Intel[®] I/O Controller Hub 7 (ICH7) Family

Intel[®] ICH7 Family Specification Update

May 2012

Figure 23-21: G3 (Mechanical Off) to S0 Timings (Mobile/Ultra Mobile Only)

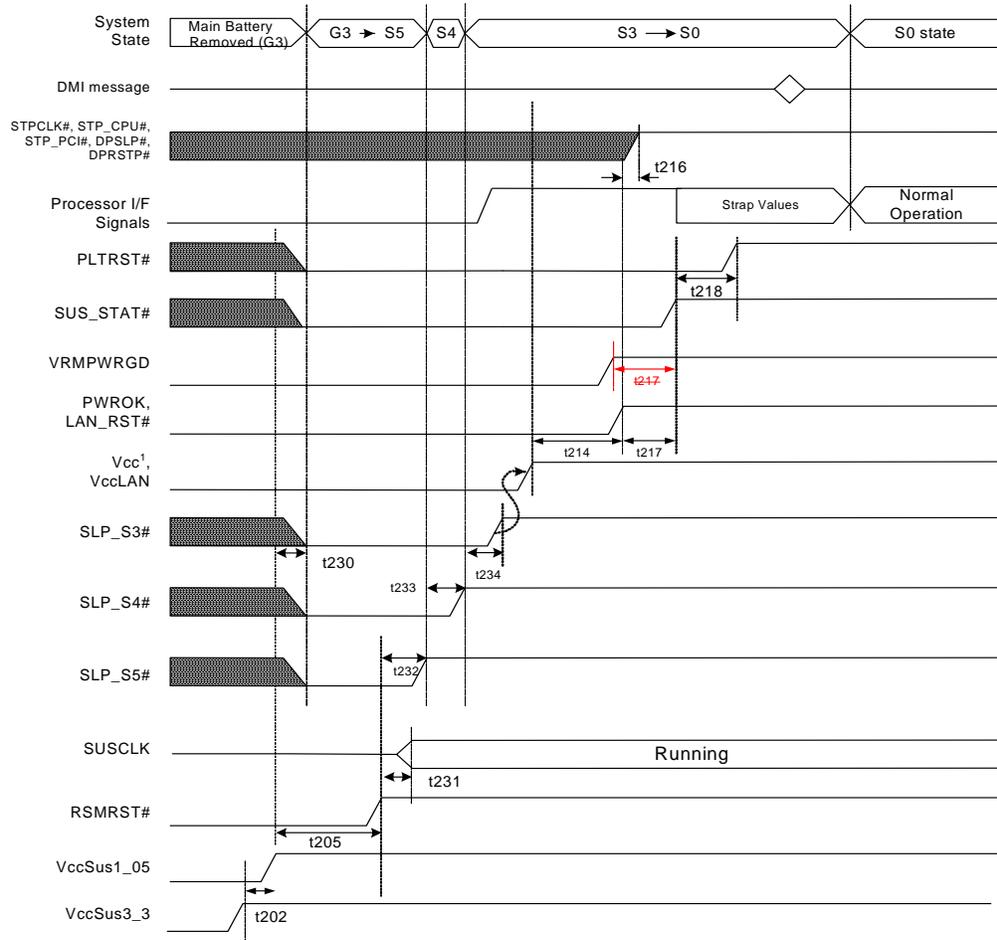
6. Remove t217 timing from Figure 23-21

Remove t217 timing that points from VRMPWRGD going high to SUS_STAT# going high from Figure 23-21: G3 (Mechanical Off) to S0 Timings (Mobile/Ultra Mobile Only) in the Datasheet.

Figure 23-25 S0 to S5 to S0 Timings, S3_cold (Mobile/Ultra Mobile Only)

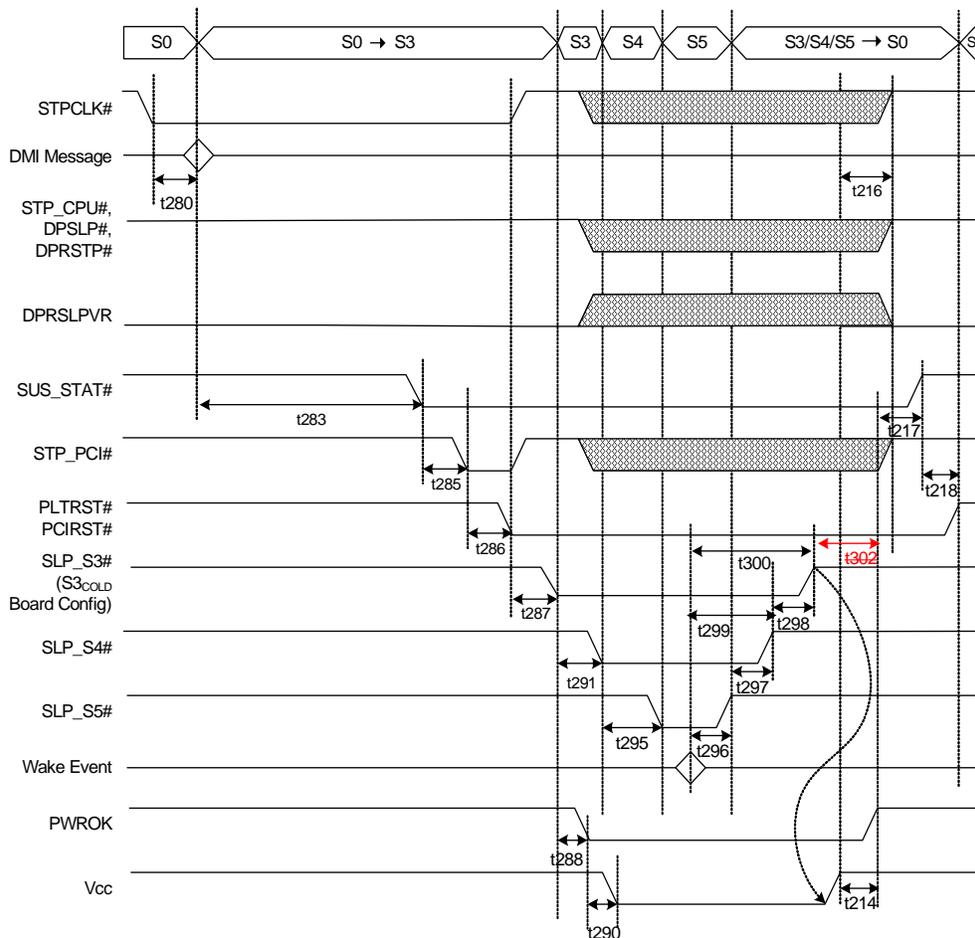
8. Remove t302 timing requirement from Figure 23-25

Remove the t302 timing requirement from Figure 23-25 S0 to S5 to S0 Timing, S3_cold (Mobile/Ultra Mobile Only) in the Datasheet.
